APPLICATION FOR A CERTIFICATE OF APPROPRIATENESS – STAFF REPORT

COA-0013-2019 308 S BOYLAN AVENUE

Nature of Project: Replace curb cut; remove 15 trees; remove portion of fence; alter driveway; construct parking areas; install metal roof

Montfort Hall  
Existing Roof Plan

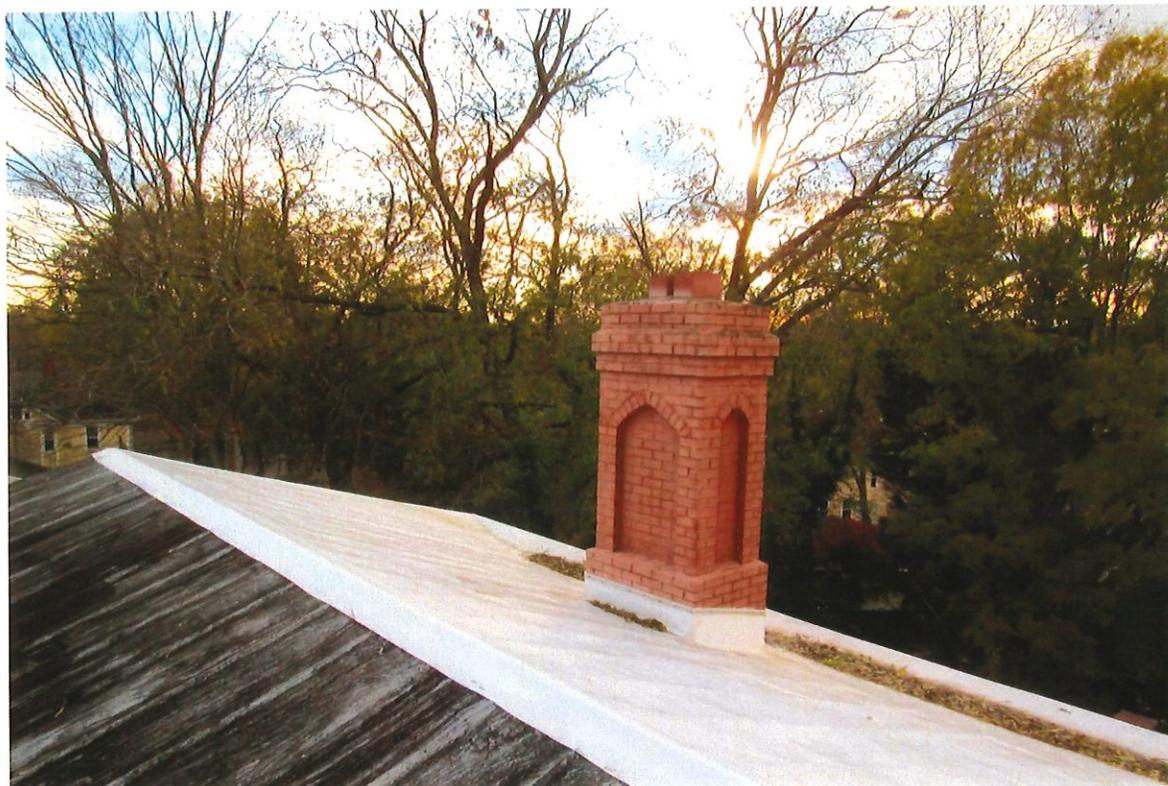
- 12\* The application proposes the alteration of the roof from coated terne and membrane (on the main building block) and asphalt (on the one-story addition) to standing seam copper. The roof is proposed to have 15" wide pans with 1" standing seam and no hip or ridge caps. Evidence of the condition of the existing roof was provided.

MONTFORT HALL  
308 S. BOYLAN AVE  
PROPOSED SITE PLAN

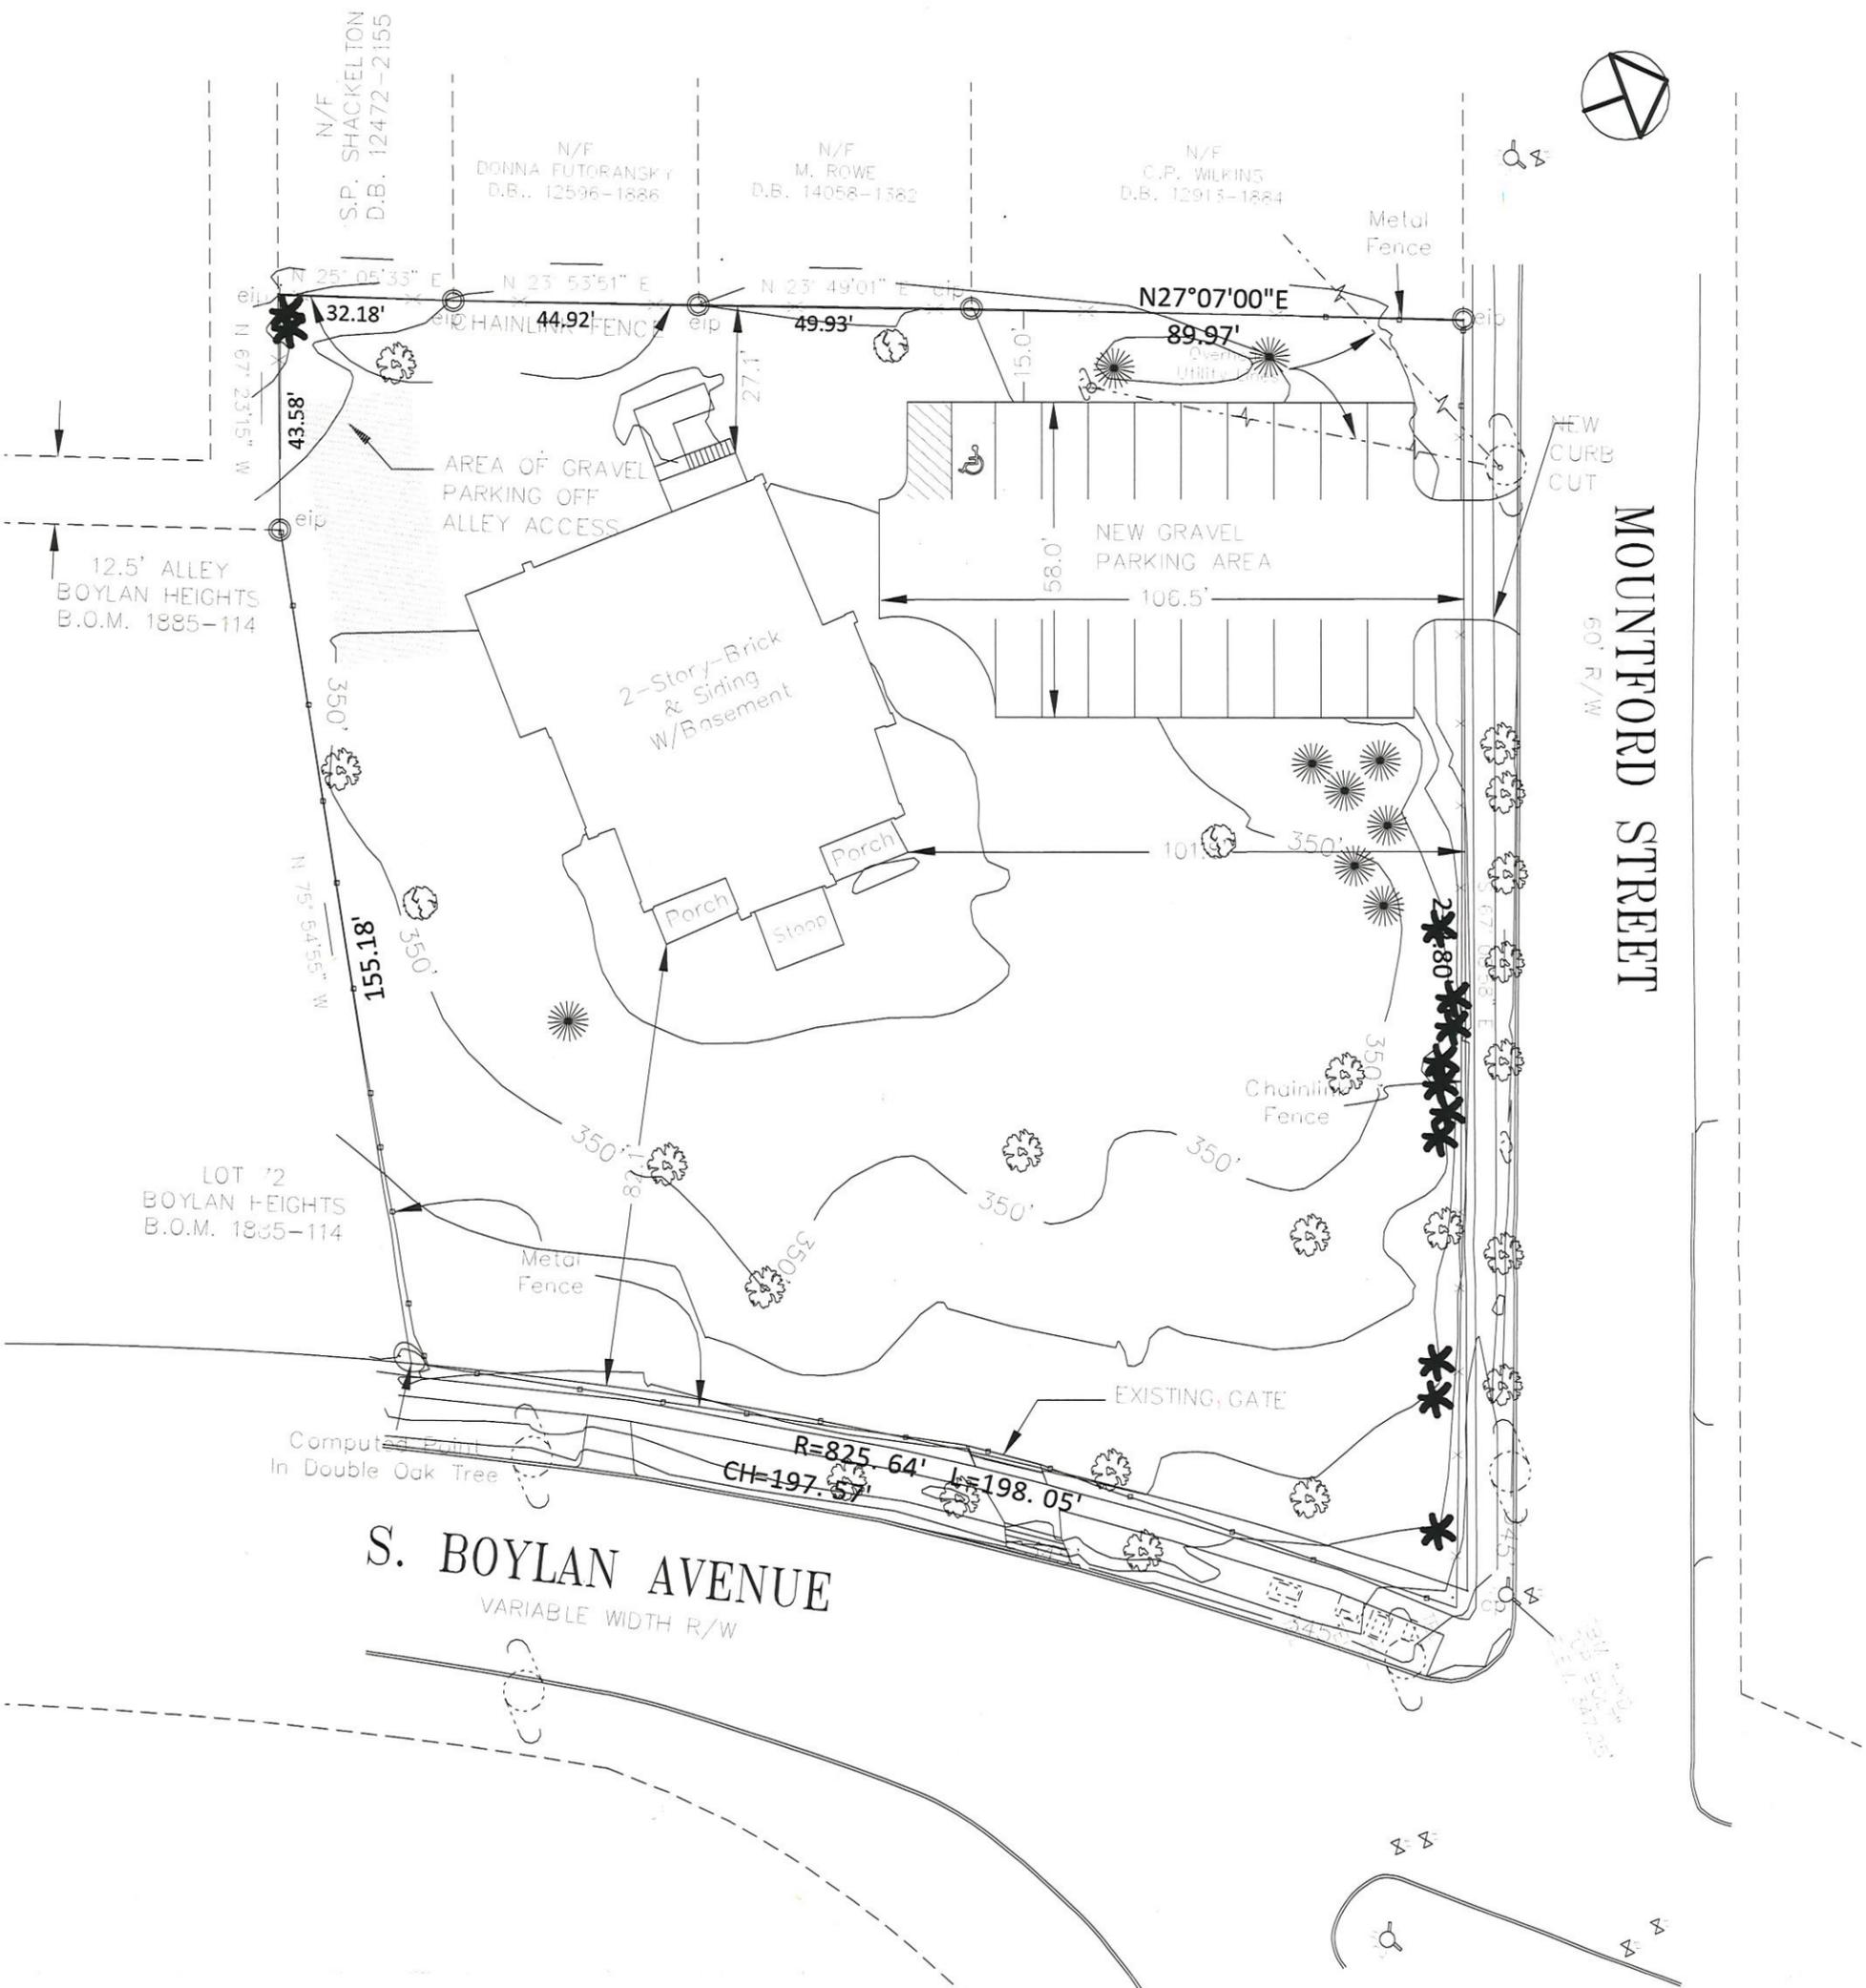
- 7\* A 19-space gravel parking area is proposed in the location of the driveway. Material specifications were not provided; grey crush and run is typical for the district. Information on screening was not provided. The application states that it will be provided in a separate COA application.

- 8\* No evidence was provided to show that the proposed parking area meets the *Design Guidelines*.
- 9\* A gravel parking area is also proposed at the rear of the house adjacent the alley.

- 11\* The proposed parking area is at the north side of the house and the southeast corner of the parking area is located an estimated 20 feet behind the front wall of the house. The proposed parking area is set 15 feet from the rear property line and an estimated 10 feet from the property line along Mountford Street.

Staff suggests that the Committee defer the application until a tree protection plan prepared by an arborist certified by the International Society of Arboriculture (ISA) or by a North Carolina licensed landscape architect that addresses the critical root zones and provides staging areas for construction activity and material storage **and** evidence that demonstrates that the proposed parking areas meet the *Design Guidelines* are provided.
